## Planning, Land Use and Mobility Committee

**Case Report: Victory Place**  
**DIR-2018-7402-SPP**  
**21201 Victory Blvd. Canoga Park, 91303**

Project: Application for a Project Permit Compliance for the demolition of an existing 2-story office suites complex and the construction of a 7-story, 99-foot high, 215,268 SF commercial office and residential apartment structure. The proposal is for 44,479 SF of non-residential space (with only 16,510 SF of that as pure office space) and with 221 residential units (including 59 Live/Work units with 20,897 SF of commercial space) on

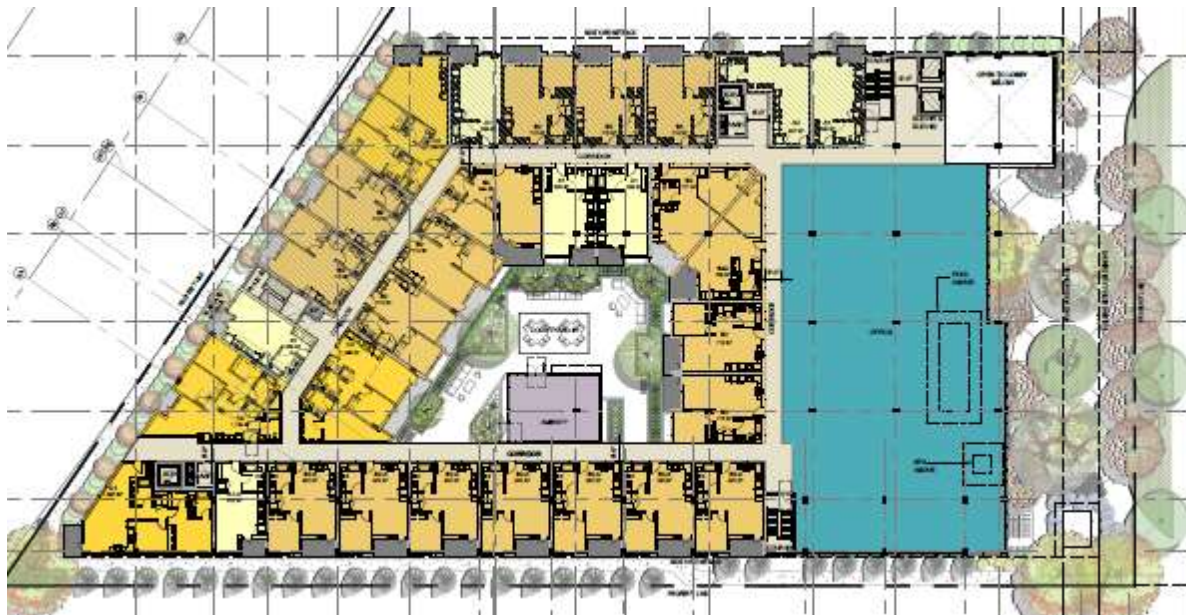
The Uptown District has a required front setback of 12 (min) - 15 (max) feet, with 30% of the front setbacks landscaped. The project plans call for a large landscaped area in front of the main non-residential entry facing Victory. The Applicant is also counting landscaping in a central courtyard and on 4 different decks (different floors) of the plan.

The Applicant has stated that the project meets the Publicly Accessible Open Space requirements of the 2035 Plan of 15% of net site area which is 9,356 SF, with 9,392 SF of provided PAOS. However, connectivity to adjacent properties or to the Orange Line is not directly spelled out in the submitted materials although the Applicant is willing to discuss possible connection with Metro. The project is within ½ mile of a major transit stop.
